**Re: AT&T Wireless Communications Facility / PS25 Camas School Relo / CUP23-03  
 Completeness Material**

**Figure 1**

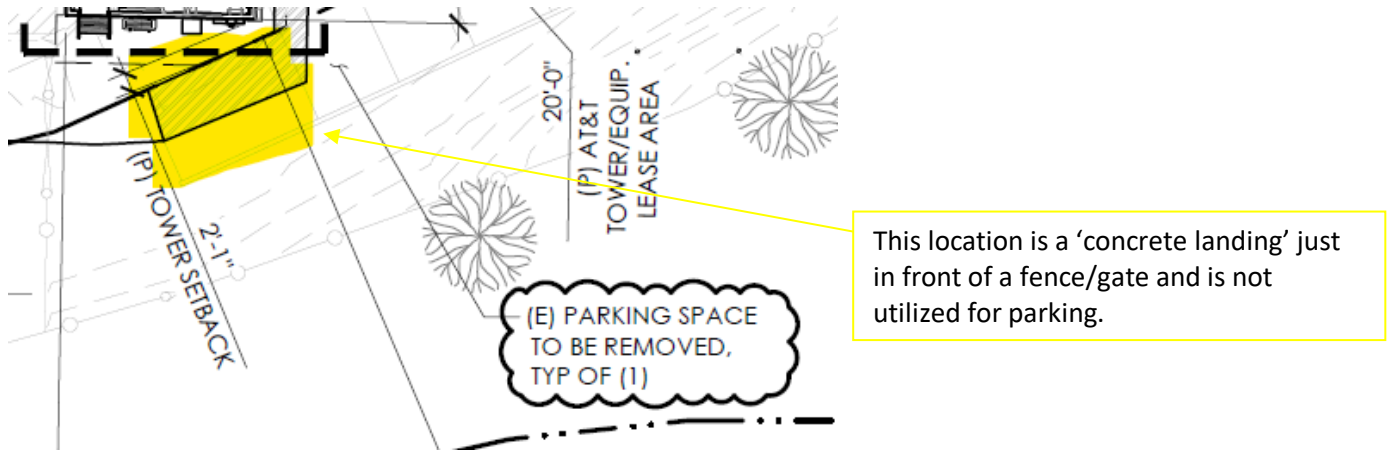
o It appears 2 parking spaces will be removed due to the tower, not the 1 parking space that is referenced.

- Only 1 space will be removed. See, Fig. 1, below.
